Class II Change Letter

To whom it may concern,
Request for Class II Permissive Change

Product Name: Barcode Scanner
FCC ID: HD5-8680B
Model No.: 8680i

8680i (Seychelles)
Main PCB Assembly

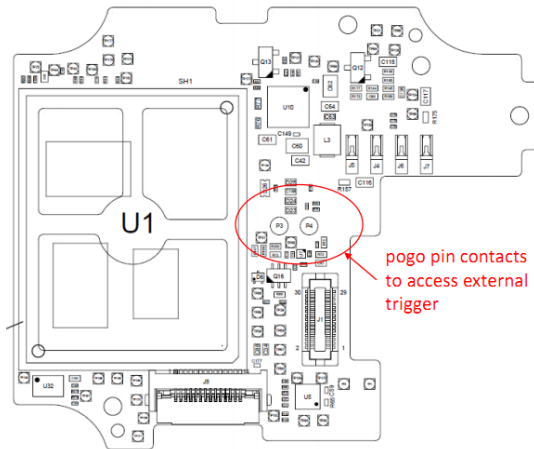
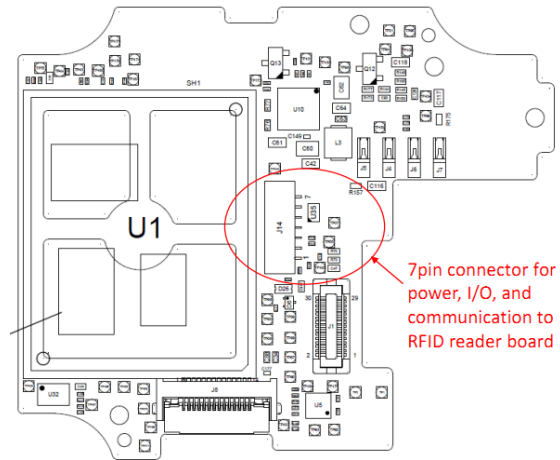
1. Modified bottom housing to expose Interface Connector RFID reader not shown

We re-evaluated Spurious emission and output power of this modified product, and the values are lower than original application, so we considered it as C1PC, the reason we apply for this C2PC is that SAR value need to be recalculate.
